STAFF REPORT
Proposed Veranda Master Plan and Subdivision

FILE NUMBER: SD/MIS 20-26000343 (MPLAN 21- 00652)

PROPOSAL: To establish an applicant-initiated Pleasant Valley Master Plan and 187-lot subdivision for an approximately 38.9-acre area. All existing improvements on the site will be removed and the current well and onsite septic system will be decommissioned.

RECOMMENDATION: Staff recommends denial of the proposed applicant-initiated Pleasant Valley Veranda Master Plan and the 187-lot subdivision.

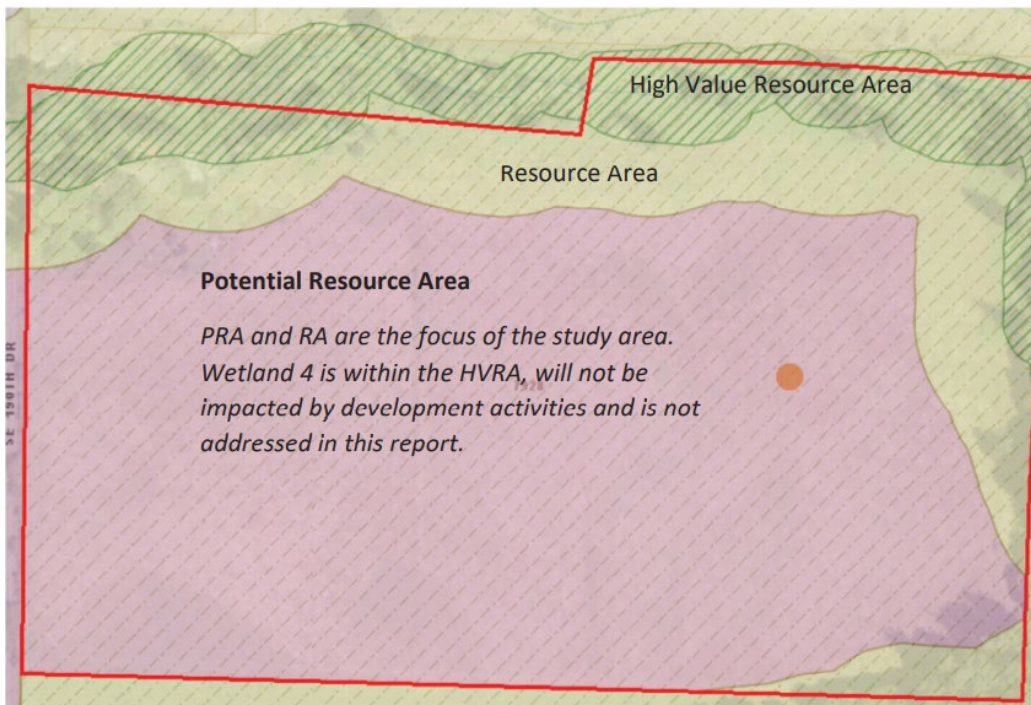
The application does not provide review of avoided or minimized and mitigated environmental impacts within the ESRA-PV abutting the 190th Ave right-of-way at the Kelly Creek crossing.

There are proposed water, wastewater, and stormwater scenarios that suggest there would be impacts within the ESRA-PV here. We have inadequate information to assess whether

those impacts would be in conflict with environmental protections for the area, or how they would mitigate for approvable impacts.

A complete mapping of all streams, wetlands, and other water bodies throughout the parcel and on adjacent parcels is required by the 2020 ESRA-PV code.

The environmental reporting submitted to DSL for the re-delineation states there will be no impacts with the Veranda development within the “HVRA/RA” area, yet there are portions of proposed tax lots and a roadway within the RA (riparian) buffer (again, RA buffers should not be used as this was submitted under ESRA-PV era), as well as stormwater treatment and/or conveyance elements presumably in this area. Thus, the information provided to DSL does not appear to be consistent with the applicant’s proposed road and tax lot layout.
